Memorandum

To: Sussex County Planning Commission Members
From: Jamie Whitehouse, Director, Department of Planning & Zoning; Lauren DeVore, Planner III, Jenny Norwood, Planner I, Christin Headley, Planner I, Nicholas Torrance, Planner I, and Chase Phillips, Planner I
CC: Vince Robertson, Assistant County Attorney
Date: October 27, 2020
RE: Other Business for the November 12, 2020 Planning Commission Meeting

The Estuary – Phase 3 (2005-64)

Final Subdivision Plan

SHEET NO.
P1.1

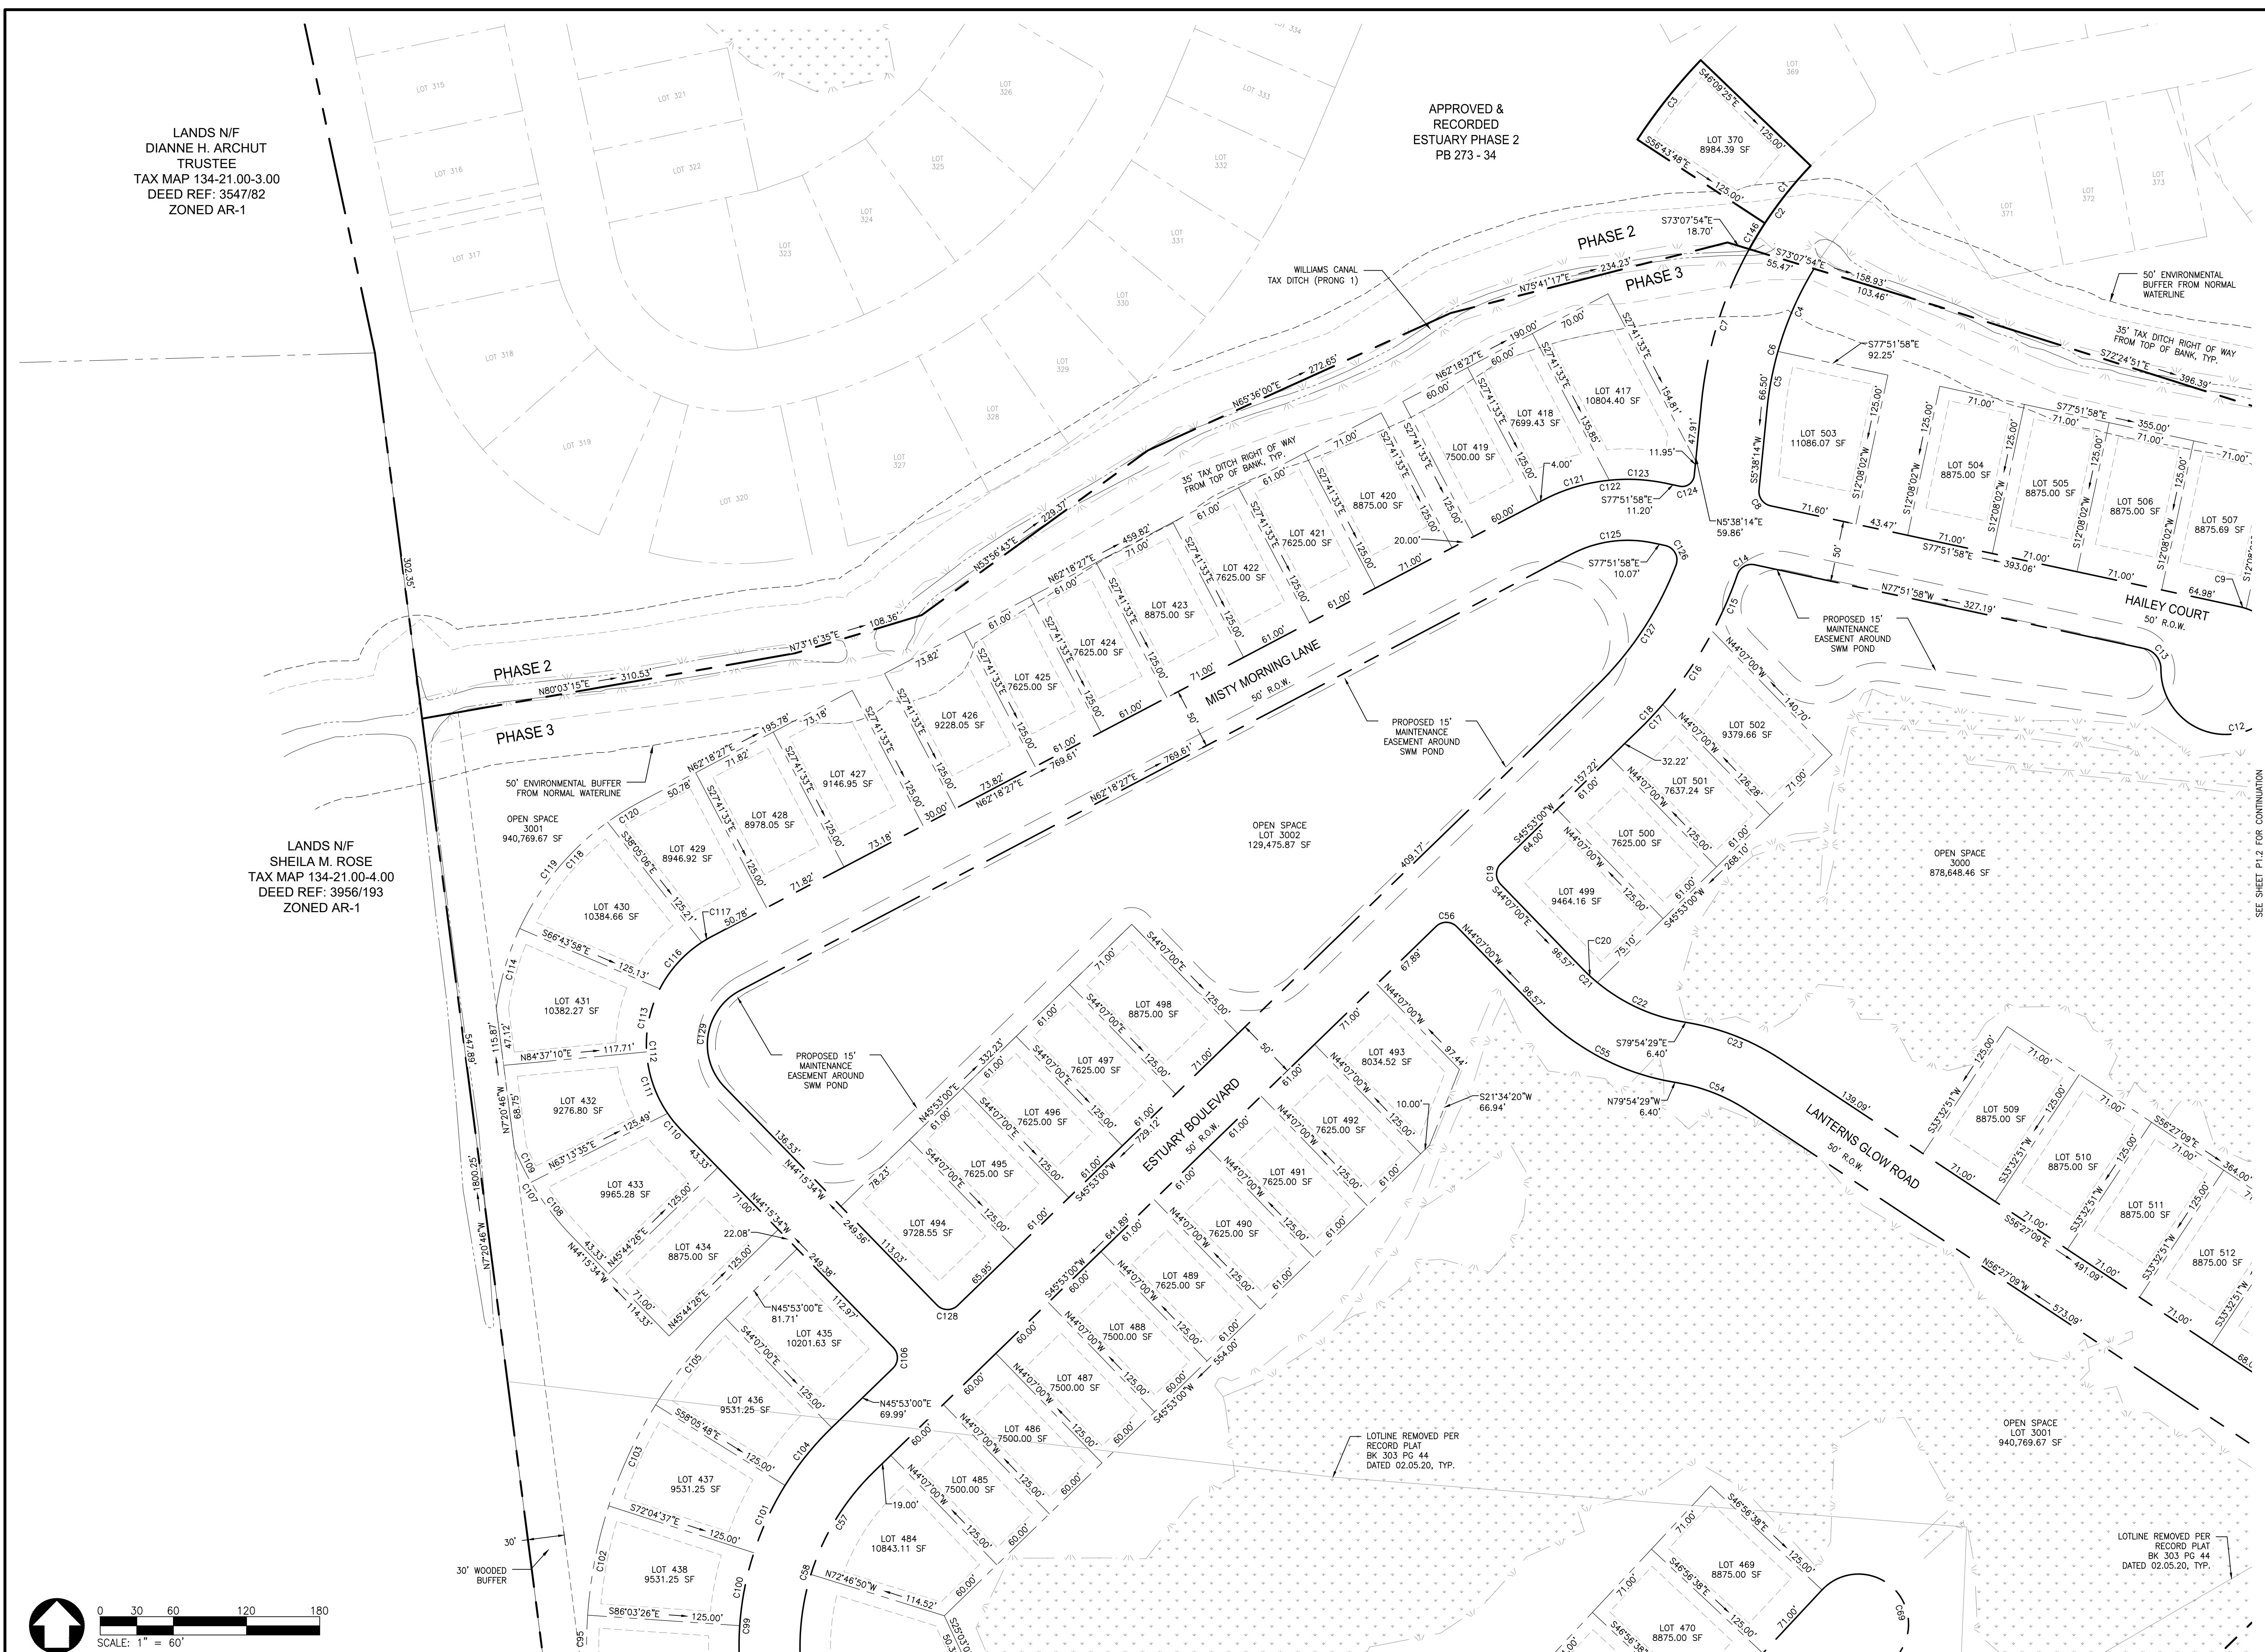
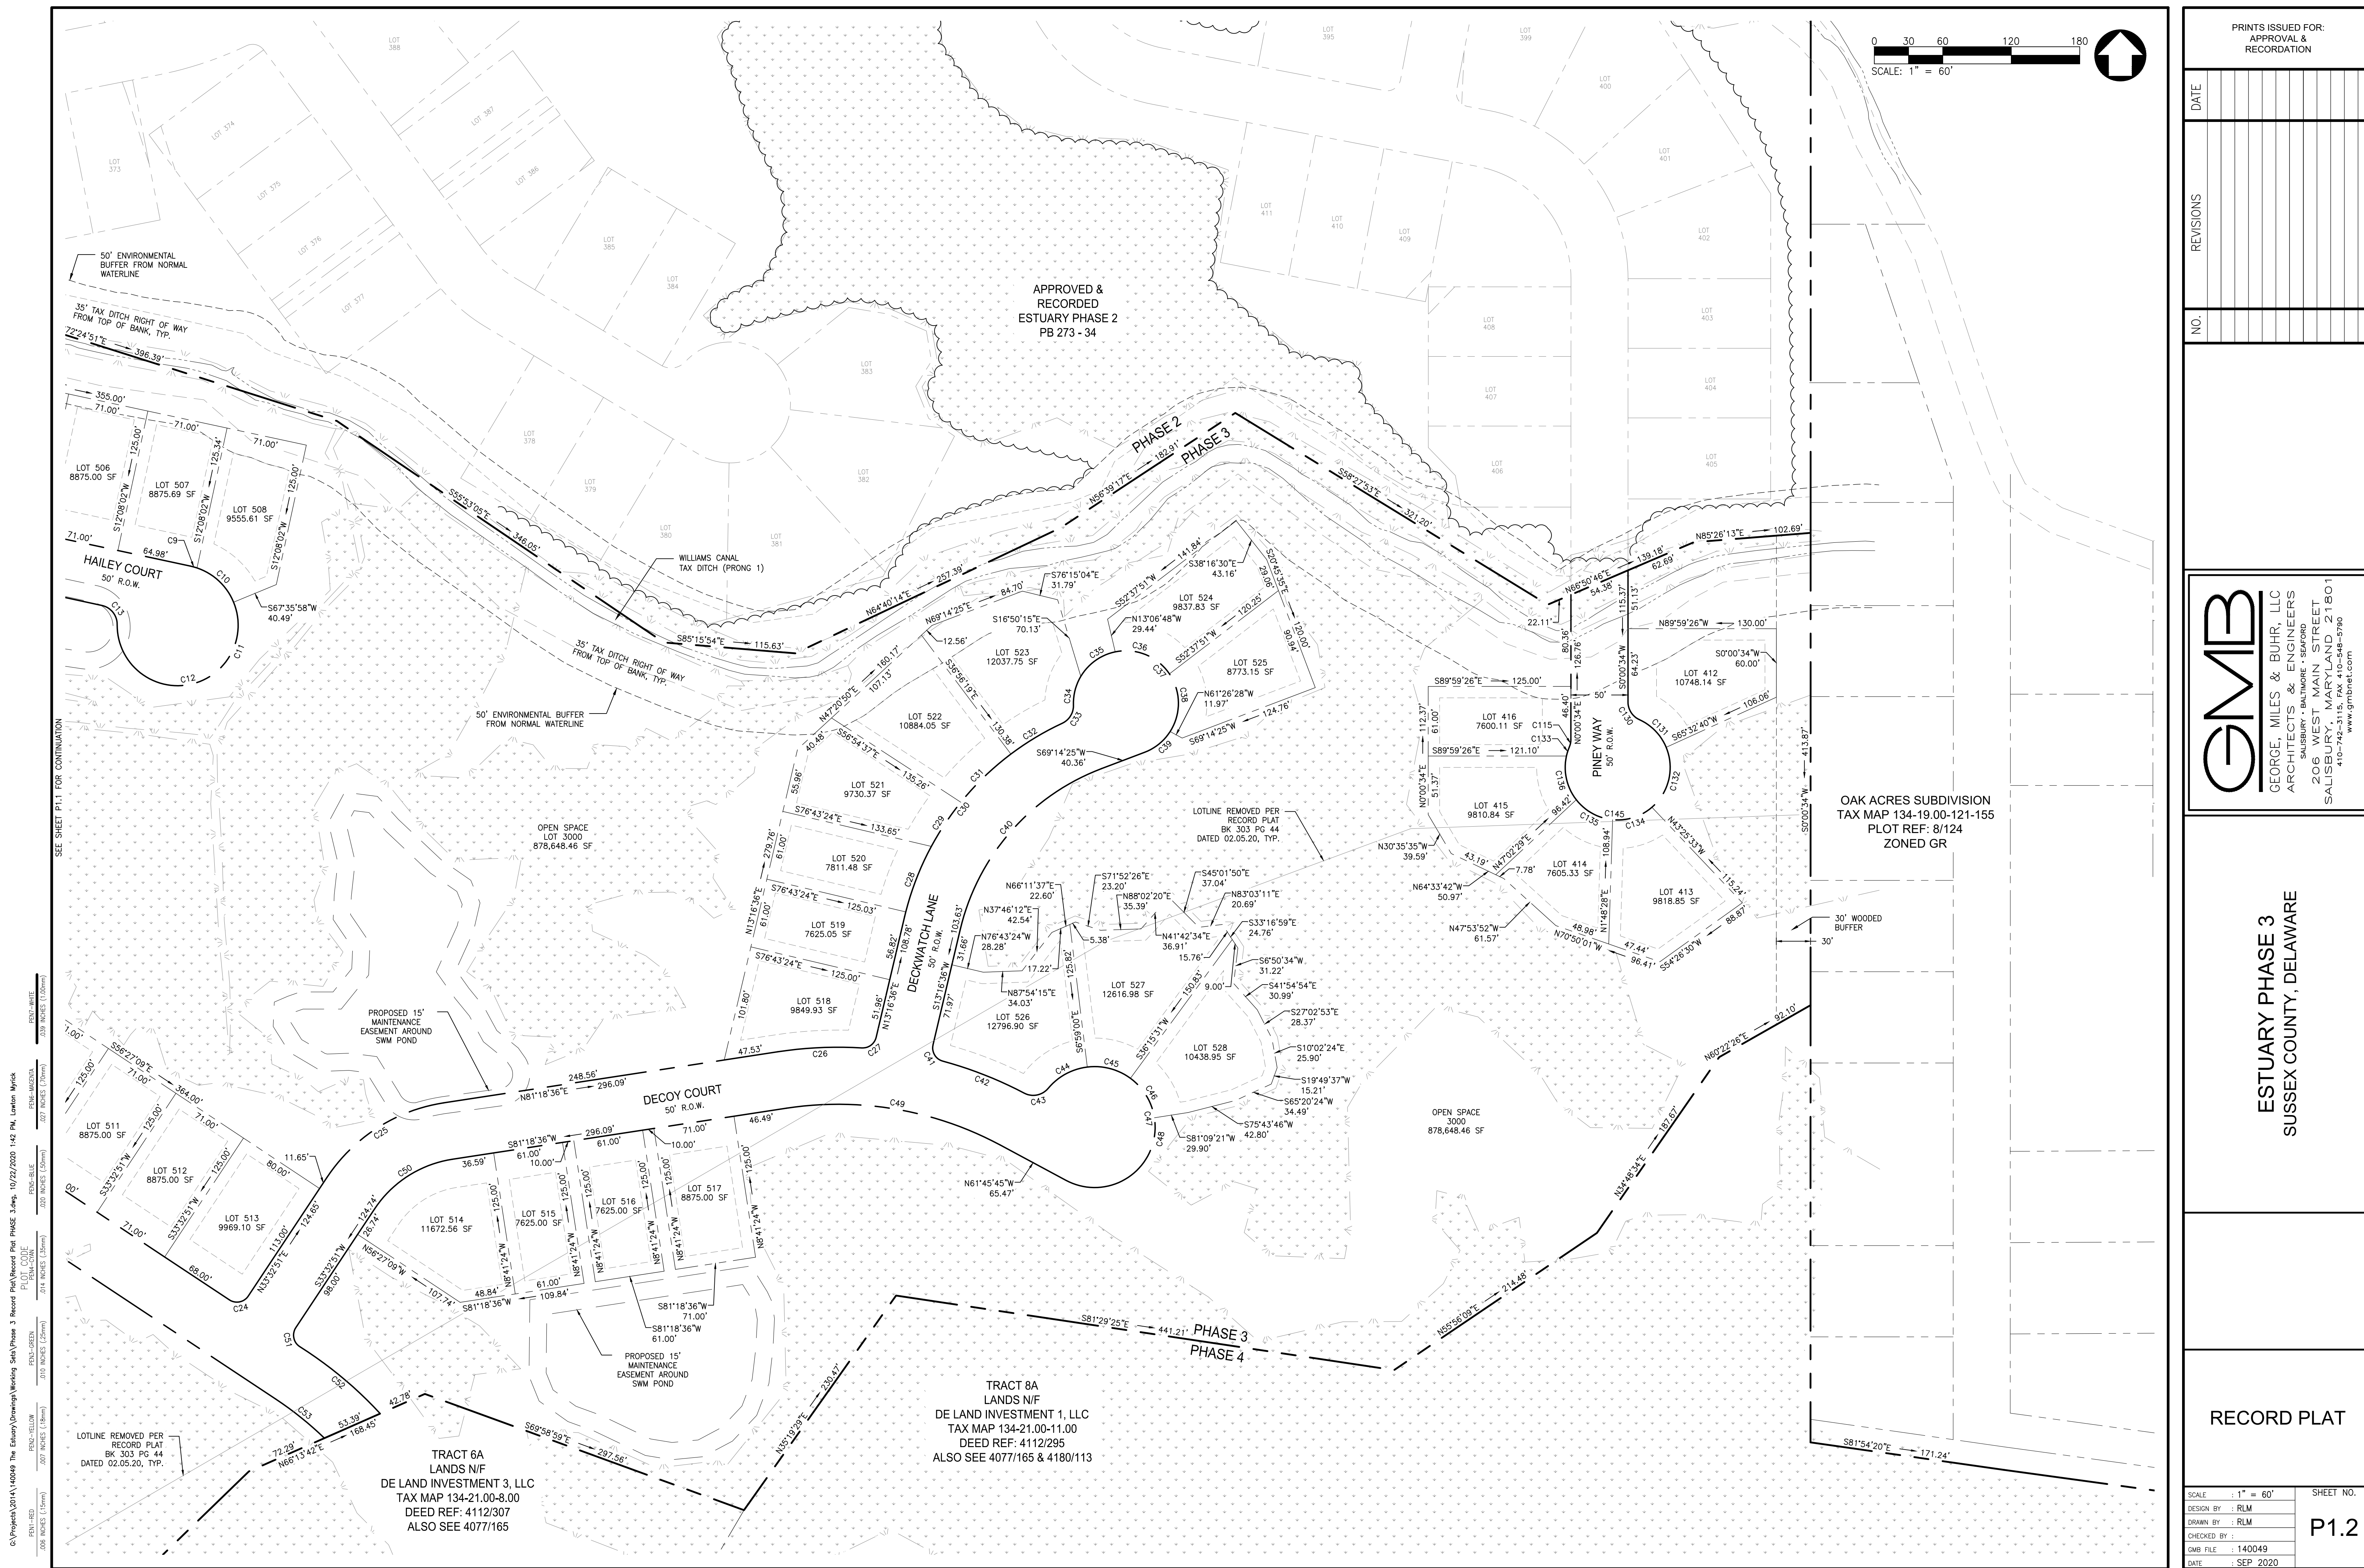
- Comment 7: Please clarify on Sheet P1.1 that the tax ditch R.O.W. is measured 35-ft from the top-of-bank (TOB).
Response 7: *A note describing "from top of bank, typ." Has been included*
